Memorandum

Re: Park Green Plan Change - RFI

I have received and reviewed Attachment 3 to the further information request issued by Auckland Council on the 28th January 2021.

Image 1 – Comparison of building coverage on Lot 21

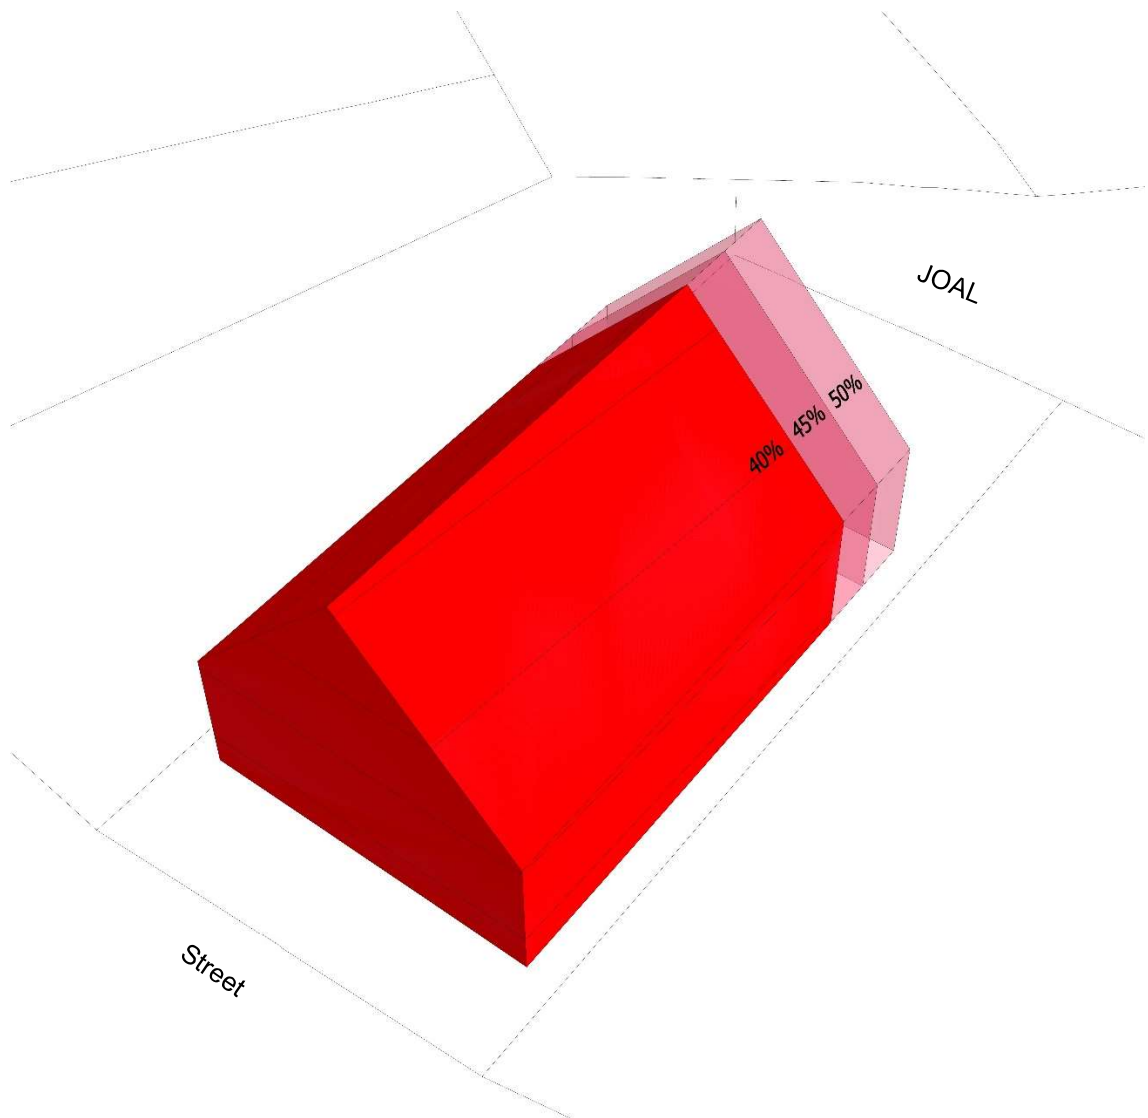
The modelling we have done illustrates that additional building coverage may not have any effect on the way the development on a site interacts with the street. Image 1 below illustrates a complying building envelope on Lot 21 in Stage 1A of Park Green assuming the land is zoned MHU. The envelope is located at the minimum front yard setback, has 1m side yards, complies with the 3m + 45° HIRB and shows the difference between 40%, 45% and 50% building coverage. This is one example of where buildings could exist on the site, and illustrates that the increased building coverage will have limited to no effect on the streetscape.

This is providing more opportunities for dwellings on a site in terms of their size which can provide for larger families, however it is not providing for greater density.

Image 2 – Lot 21 with 50% building coverage and comparison of MHU HIRB (red) and AHIRB (pink).

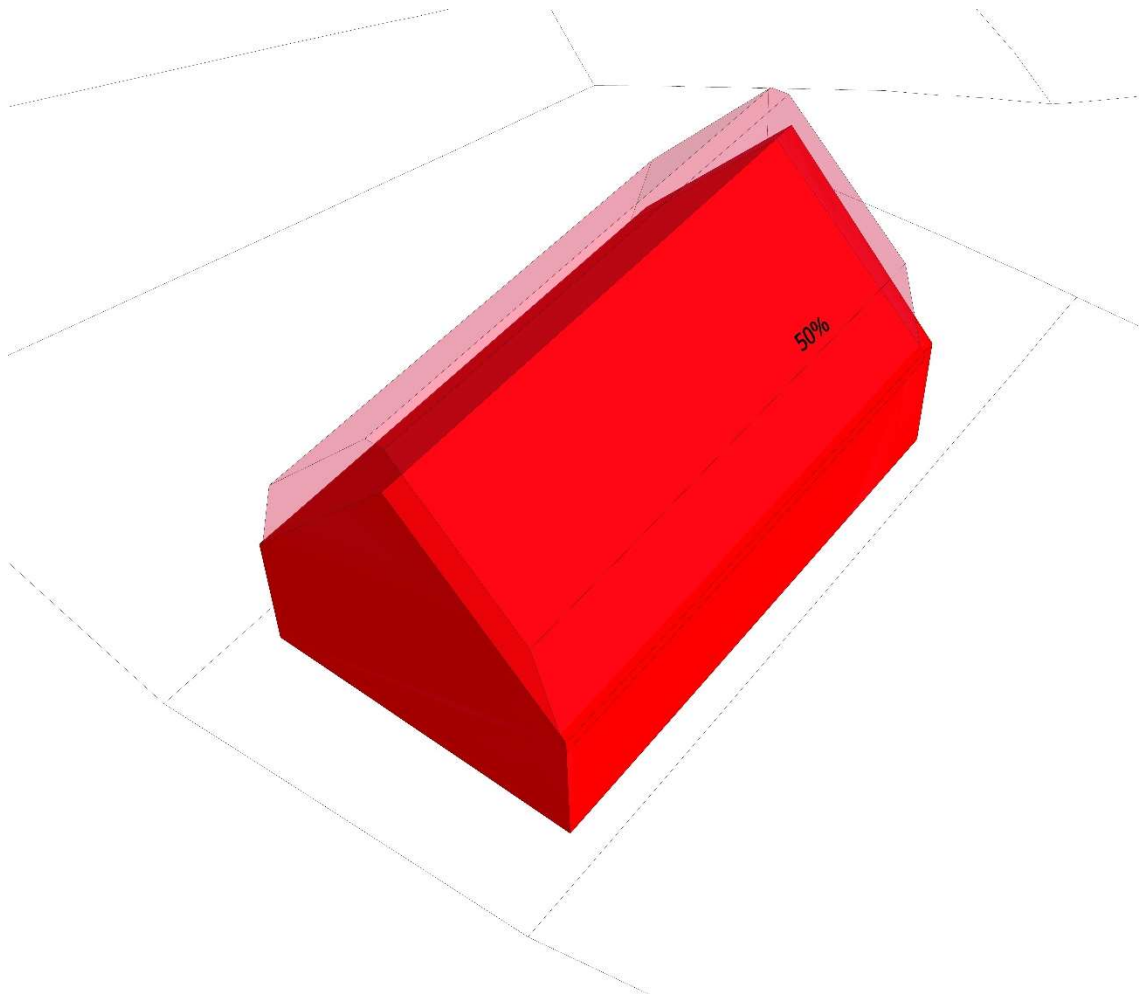
Image 2 below provides an example of the difference between the possible bulk using the MHU HIRB and the AHIRB on Lot 21 and with 50% building coverage.

The potential to use the AHIRB without further assessment will result in a further reduction in sun access but the model suggests that at least 4 hrs of sun can be achieved to 75% of an open space area bigger than 20m².
